Our File: ZON 6-09-04

APPLICATION FOR ZONE CHANGE

MEETING DATE: July 12, 2010
REPORT NO.: 2010-197

Reeves Realty Corporation
95 Young Street
Woodstock, ON N4S 3L6

**MCKEAND RIDGE CONDOMINIUM
 SITE PLAN**

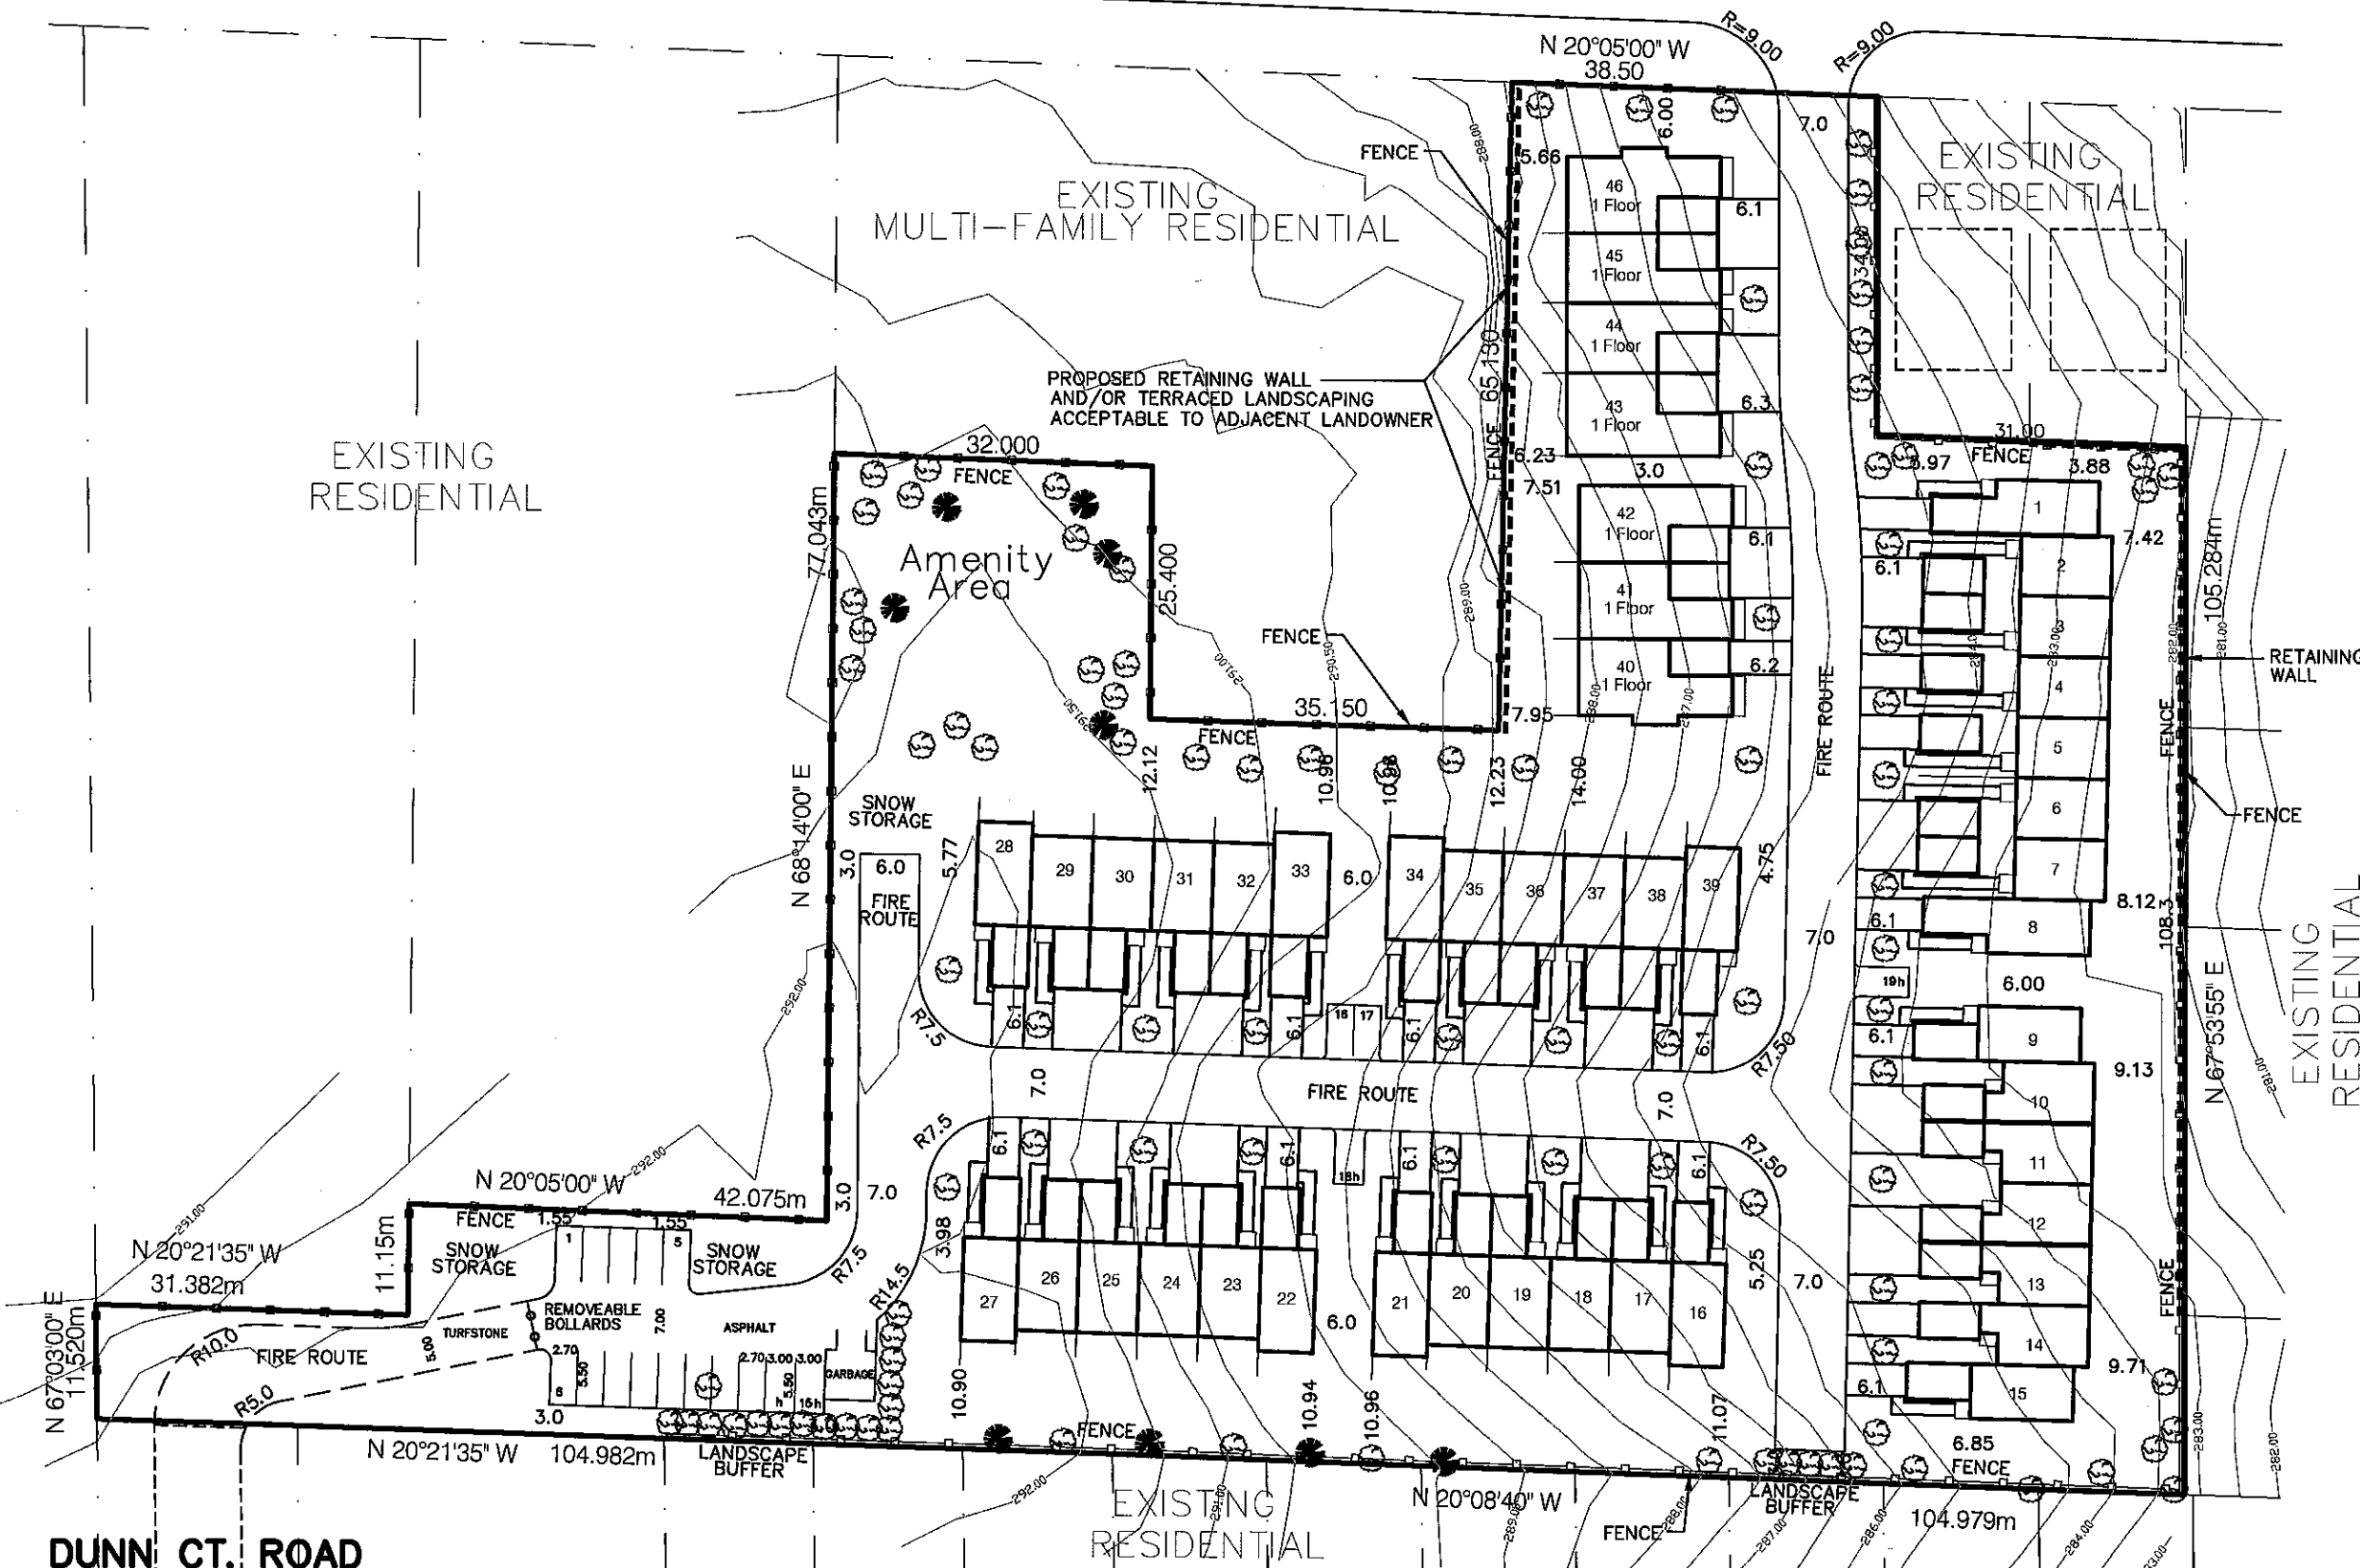
- *Some of the comments can be addressed through either the site plan control process or the building permit application.*
- *The setback between Units 42 and 43 will not meet the requirements of the Ontario Building Code without further details. I would recommend that a 6 m setback be maintained between all units.*
- *The rear setback to Unit 15 will require a variance from 7.5 m to 6.85 m.*
- *All rear decks should be shown on the site plan in order to confirm setback requirements.*
- *If the total building area exceeds 600 m², an architect and engineering drawings will be required for the building permits application."*

Rear Yard Setback – required 10 m – proposed 6 m – drawing shows 6.85 m to the fence.

Height – shown as 3-storey, presently zoned for 1-storey – site data should be amended.

Parking – shows 92 spaces required and 111 spaces provided. Can the spaces be identified as:

Should a provision be made for H/C accessible parking in the Visitor parking area?

The drawing shows removable bollards immediately north of the parking area, should consideration be given to some mechanism to impede traffic from entering the area from Dunn Court Road?

Additionally, are the garages on Units 2 through 7 inclusive separated from the dwellings and if so, are there setback requirements?"

- 1. The current zoning only allows for single storey units not two storey units although the current zoning by-law allows for three storeys.*
- 2. Drawing 1 – McKeand Ridge Condominium Site Plan scale is incorrect. The scale noted is 1:500 when the actual scale is 1:400.*

- 3. The Site data table is incorrect in that the minimum front yard setback should be shown as 7.5 metres; landscaped open space minimum is 30% not 40%; interior side yard minimum required is 4.0 metres not 3.0 metres; lot coverage minimum is 40%. Variances for the front yard and rear yards would be required.*

- 5. Fire has indicated that they would like to have the turning radius reviewed to ensure that all emergency vehicles can properly access the site.*
- 6. The removable bollards should be directly off the end of Dunn Court Road.*
